# SAFETY RELATED RECALL

Global Recall Action  
Number: N789v2

<b>Subject:</b>  <b>Second Row Seat Armrest Stowage Compartment Latch</b>	Publication No.: N789v2
	Model: Range Rover (LK)
	Model Year: 2022 - 2023
	Model: Range Rover Sport (L1)
	Model Year: 2023
	Date of Issue: 10 December 2024

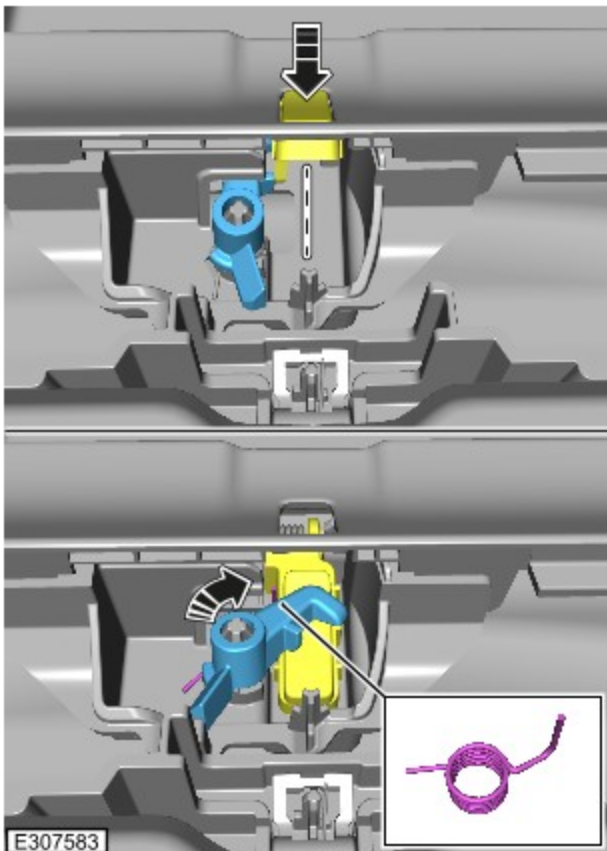
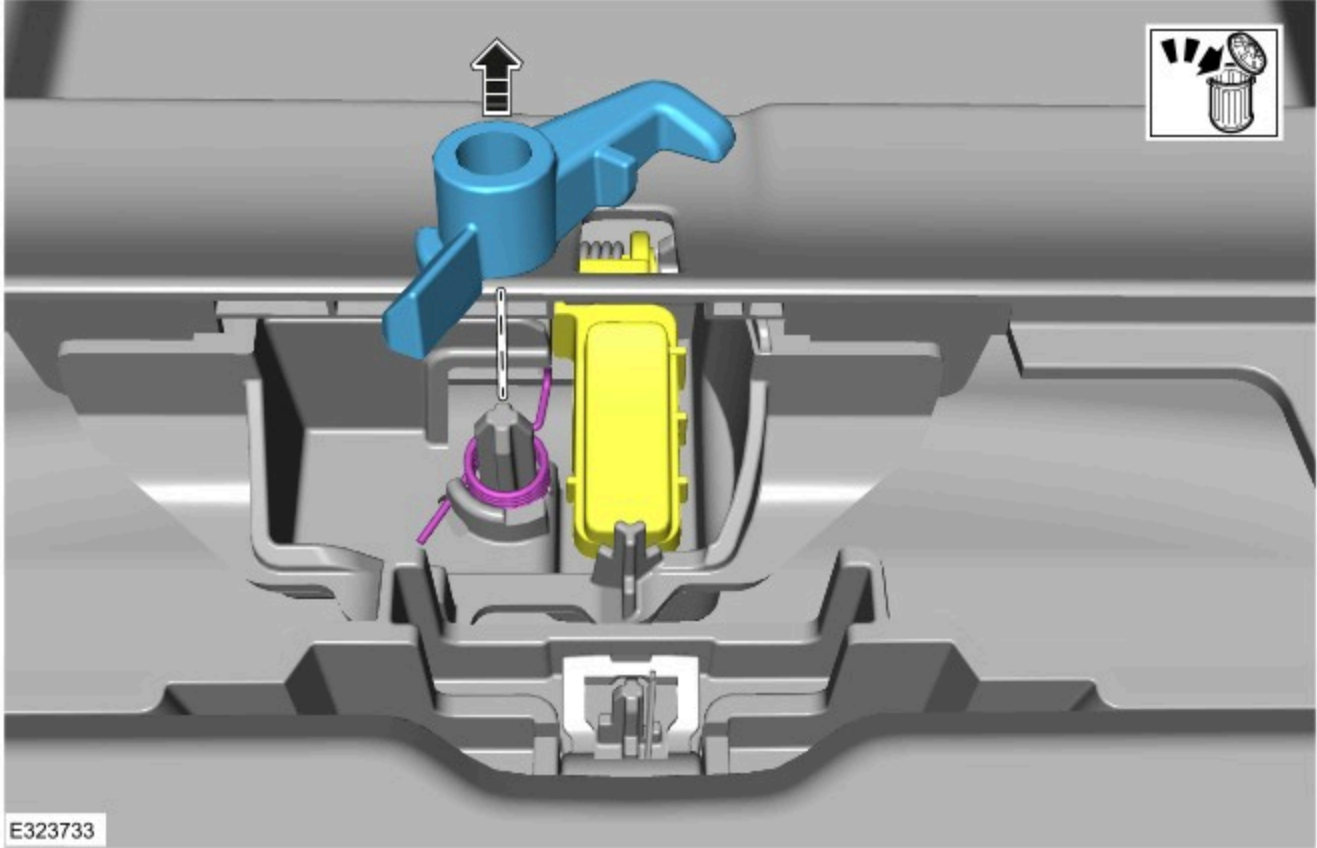
Press down on the lever and hold in position while rotating the locking arm clockwise.

Remove and discard the locking arm and release the lever.

Owners will be notified and instructed to take their vehicle to an approved JLR repairer / authorized repairer. The locking arm of the second row armrest stowage compartment latch will be replaced with a component of a revised design and material specification. There will be no charge to the owners for this repair.

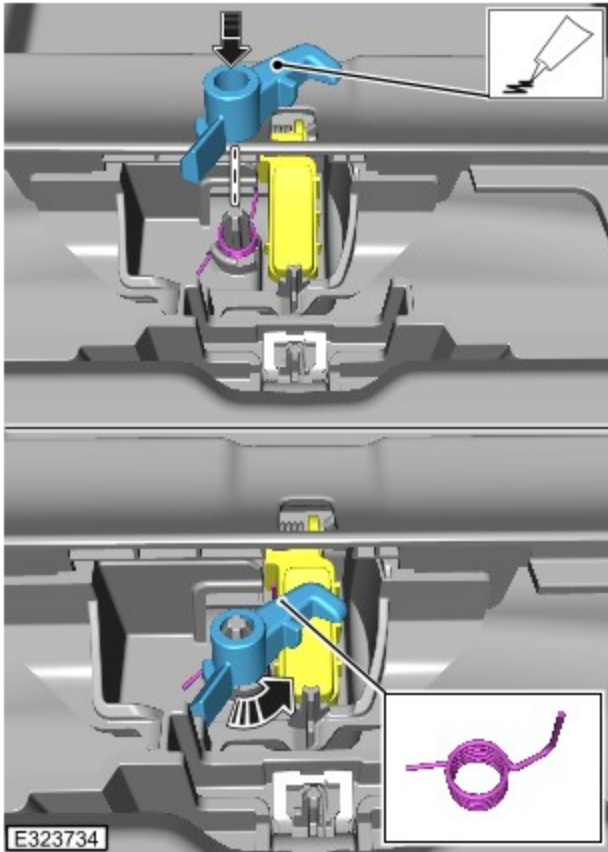
- Before installing the new locking arm, apply a small amount of the grease provided to the top of the locking arm.
- Make sure the spring is located correctly.

With the lever held down, install the new locking arm and rotate it counter-clockwise to its original position.
